STANDARDS AUSTRALIA/STANDARDS NEW ZEALAND

Amendment No. 1
to
AS/NZS 3123:2005
Approval and test specification—Plugs, socket-outlets and couplers for general industrial application

SUMMARY: This Amendment applies to the Preface, Clauses 7.1, 7.2, 7.3 and 7.4, and Figure 7 (new).

FIGURE 7 KEYWAY WARNING SYMBOL

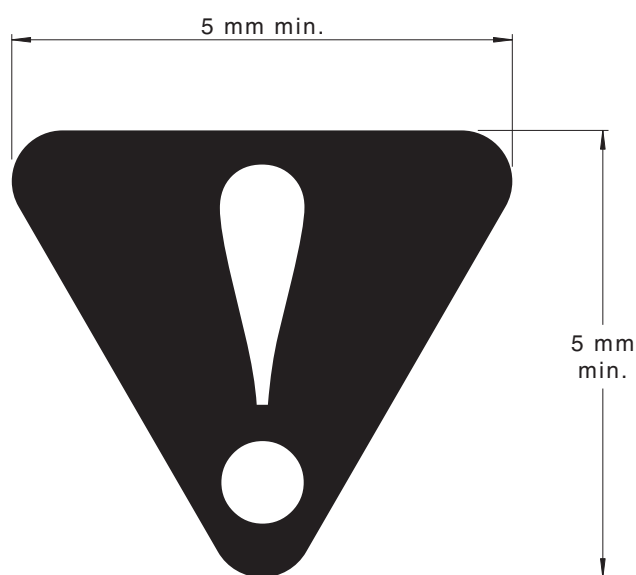
Add the following figure after Figure 6:

NOTE: The triangle is to be a solid infill as shown

- (g) On products referenced in Standard Sheets 9 and 10, a warning for keyway connection with the words 'ENSURE CORRECT INSERTION OF KEYWAYS' or the 'keyway warning symbol' (see Figure 7).

After the last symbol, *add* the following symbol:

Keyway warning symbol (if used)
